ADDENDUM NO.: 1

PROJECT NAME: Inclusive Bathroom and Site Improvements, Glen Oak Park

DATE OF ISSUE: 09/06/2024

NORTH
SK-1

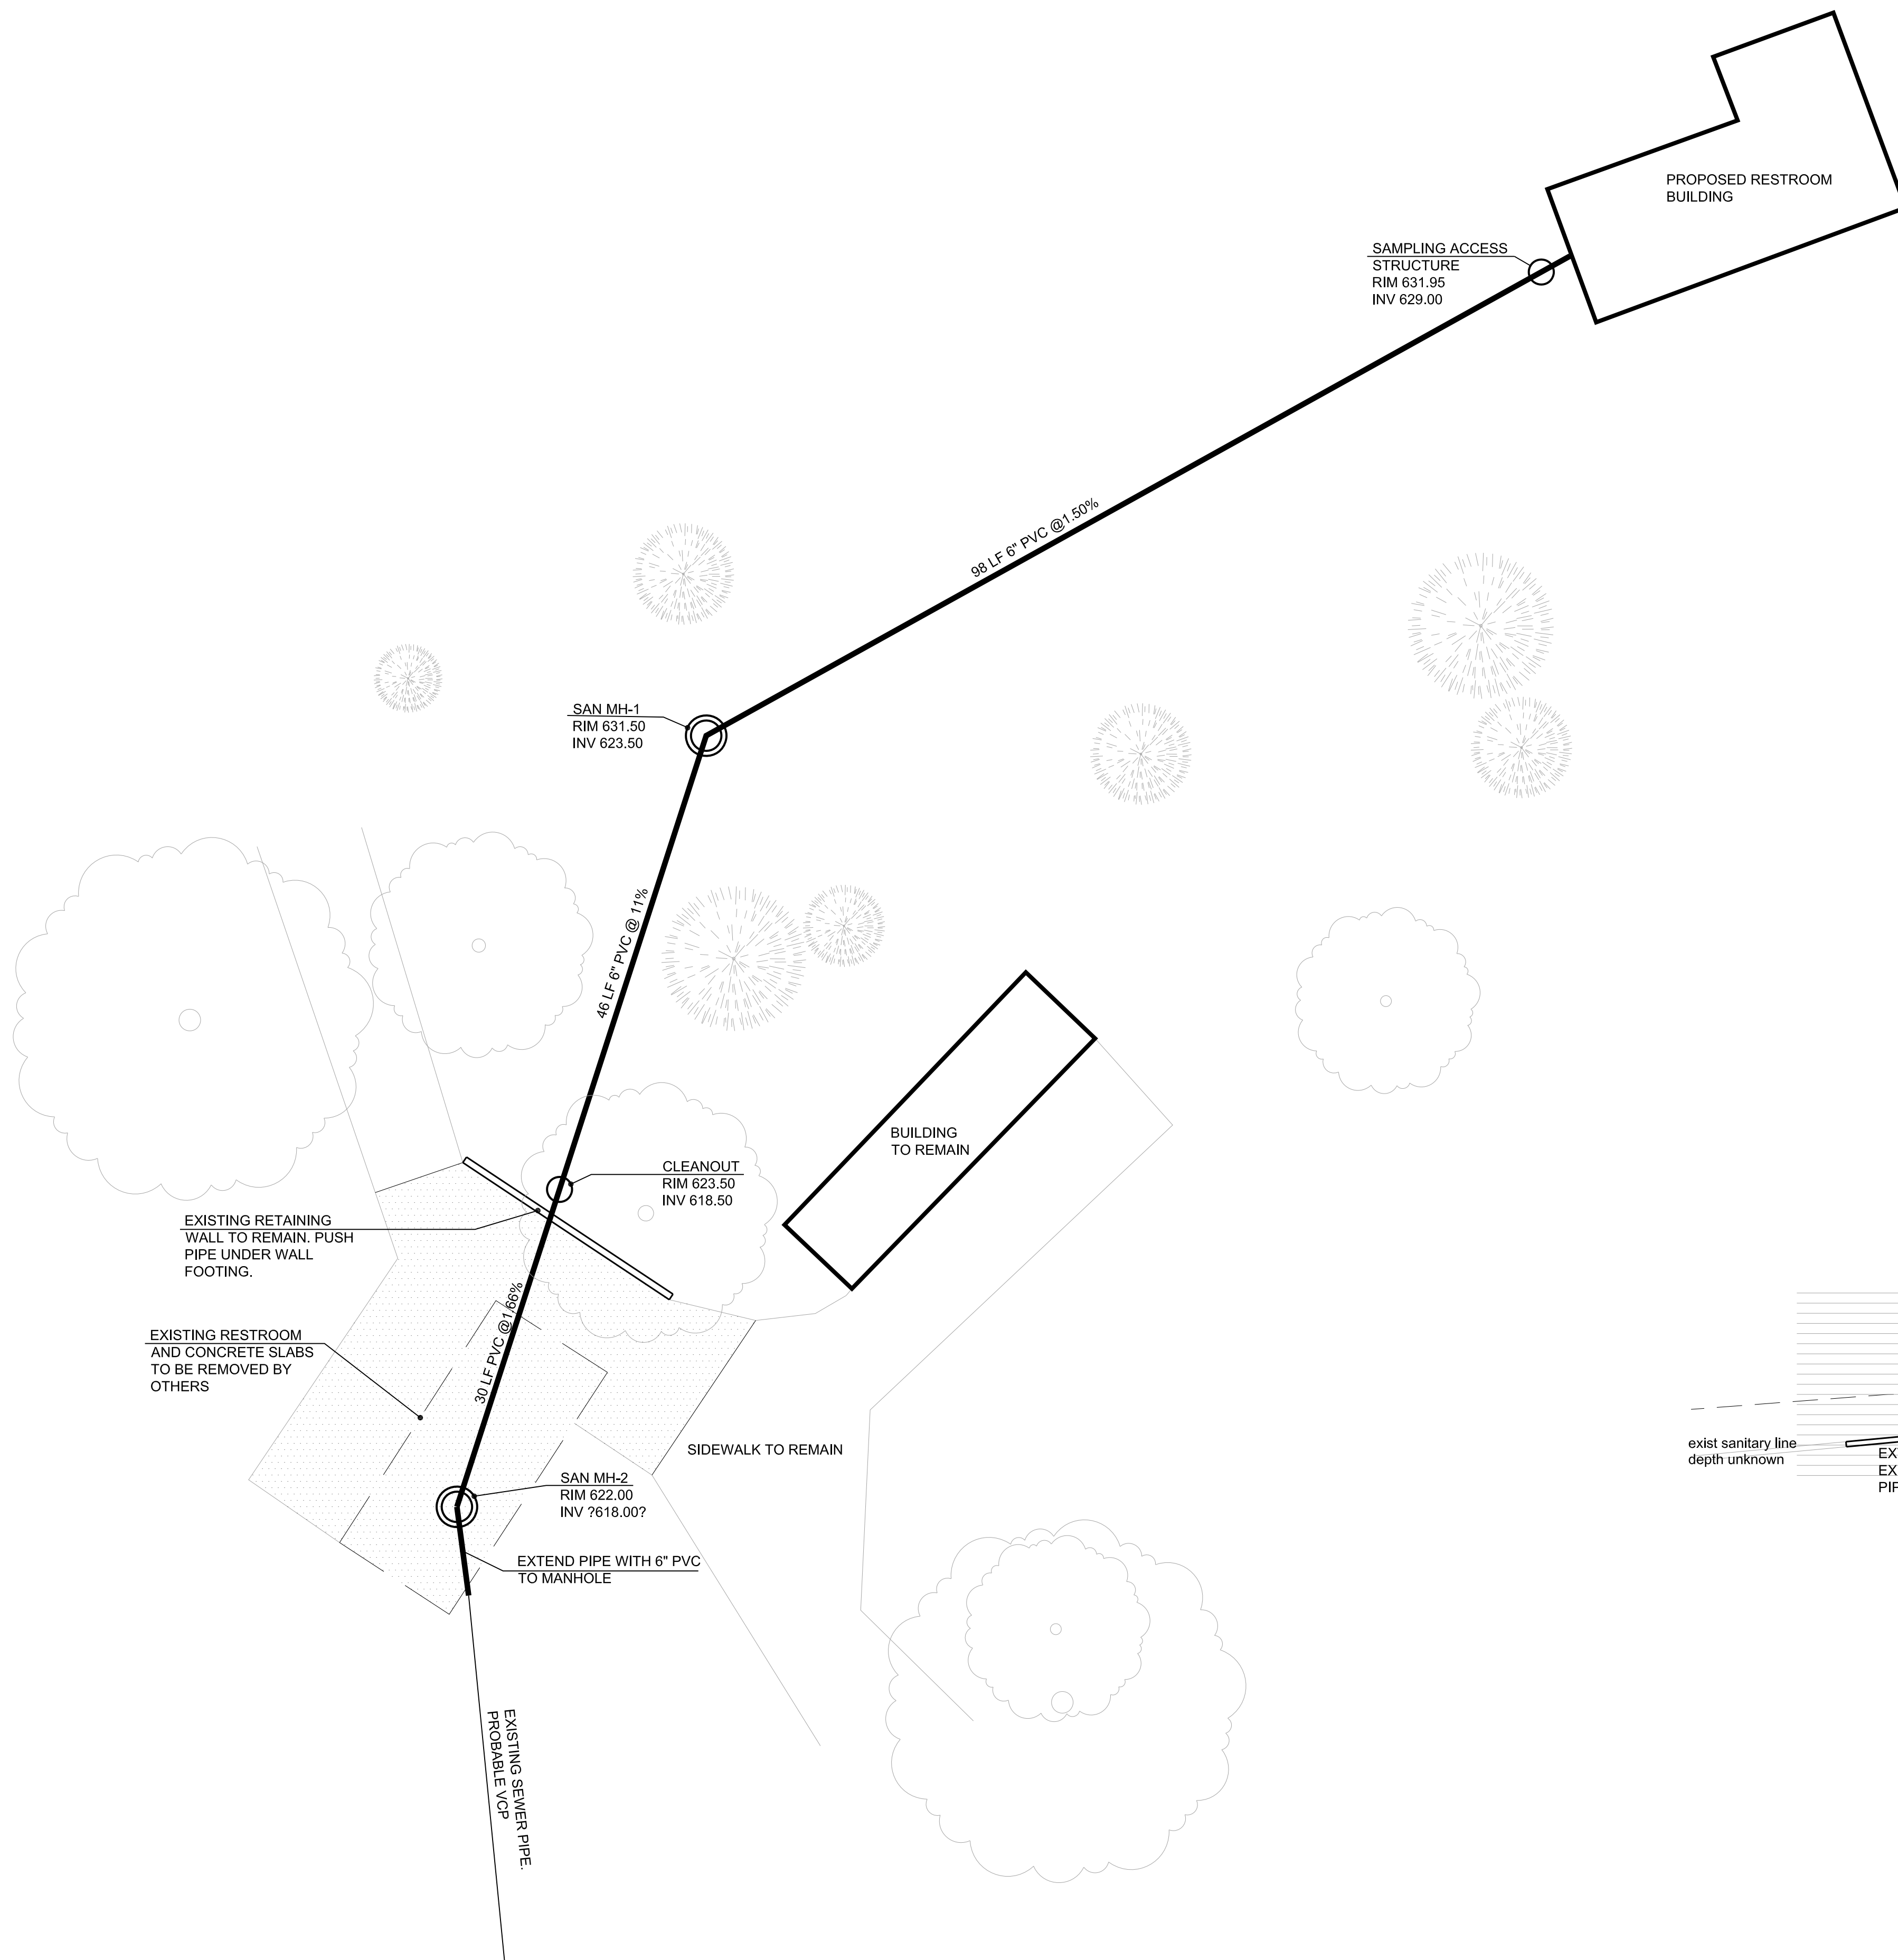
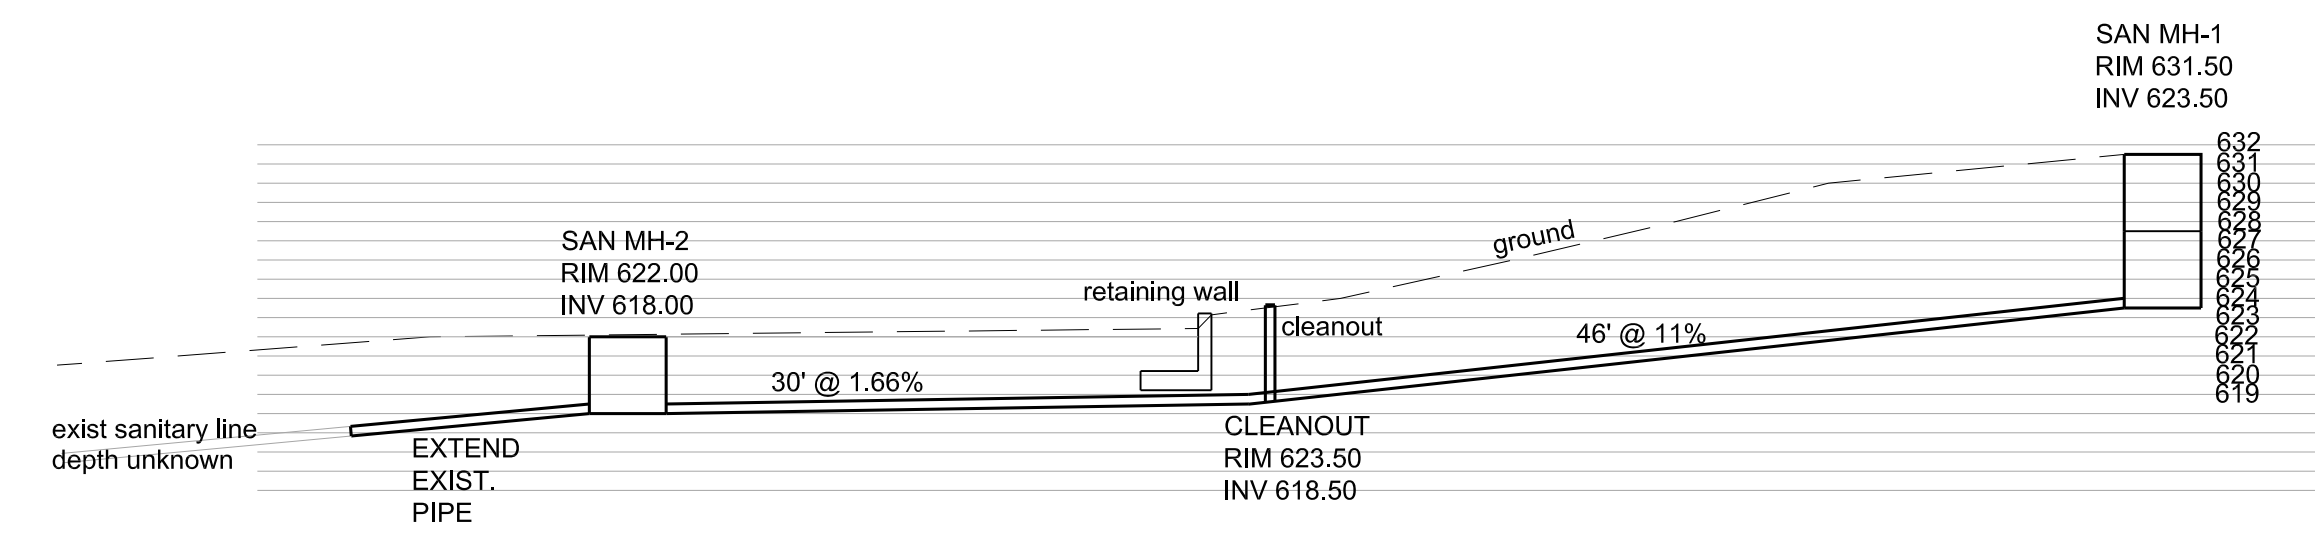
6. The manhole STM-MH2 shown on C-300 is not present. Where should we tie into existing sanitary?

RESPONSE: See attached SK-1

1 Proposed Sanitary Sewer Profile
horizontal scale: 1" = 10', vertical scale 1"=10'
